# UNITED STATES PATENT AND TRADEMARK OFFICE

APPLICATION NO.	FILING DATE	FIRST NAMED INVENTOR	ATTORNEY DOCKET NO.	CONFIRMATION NO.
10/774,876	02/10/2004	Richard Wayne Corbitt		8795

## Office Action Summary

Mignano, Figure 4

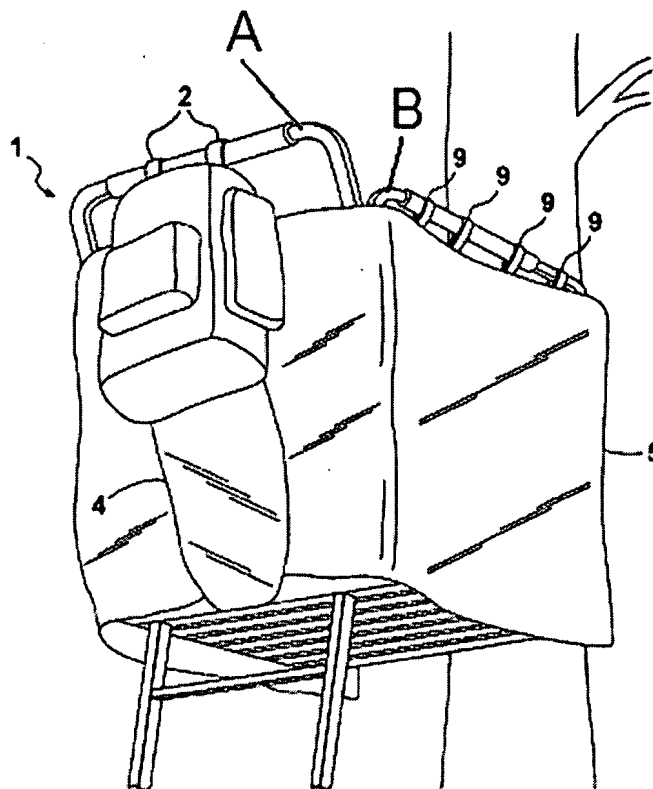
b. Regarding Claim 1, Mignano teaches a rigid frame (A, as seen in Figure 4, below) that supports a backpack (1) and a concealment blind (5) from an elevated tree stand position.

- c. Regarding Claim 2, Mignano teaches entry compartments (6) on the user side, facing an occupant of the blind.
- d. Regarding Claim 3, Mignano teaches that the frame hangs in a vertical position (best seen in Figure 4).
- e. Regarding Claims 4 and 5, Mignano teaches a backpack (1) and two permanently attached concealment blinds (5).

- f. Regarding Claim 6, Mignano teaches a backpack (1) that converts into a concealment blind (best seen in Figure 2).
- g. Regarding Claim 7, Mignano teaches that the backpack retains its function and utility as a pack (best seen in Figure 4).
- h. Regarding Claim 8, Mignano teaches that the backpack is part of the blind when in use (best seen in Figures 2 and 4).
- i. Regarding Claim 9, Mignano teaches a concealment blind (5) and a pack (1) that hangs outside of a tree stand's user space (Best seen in Figure 4).
- j. Regarding Claim 10, Mignano teaches a weapon/equipment holder (B) located on top of the frame (the upper side of the frame at B can be used to hold equipment).
